APPENDIX 117

UNITIZATION PROCEDURES FOR BOXED AMMUNITION AND COMPONENTS ON 4-WAY ENTRY PALLETS

SMOKE POT, PACKED ONE PER STEEL DRUM, UNITIZED 27 DRUMS PER 40" X 48" PALLET; DRUM SIZE 13 7 DIA X 15 1 H

REVISION NO. 1 DATED AUGUST 1988, CONSISTS OF:

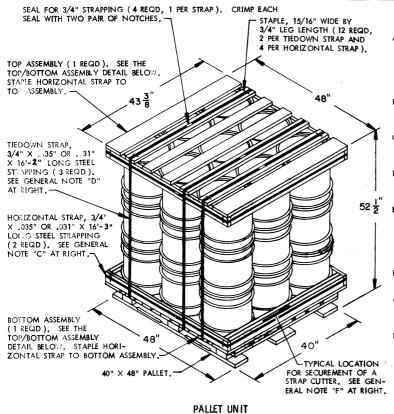
- 1. CHANGING DRUM DIAMETER,
- 2. UPDATING PALLET UNIT TO CONFORM TO 1. ABOVE.
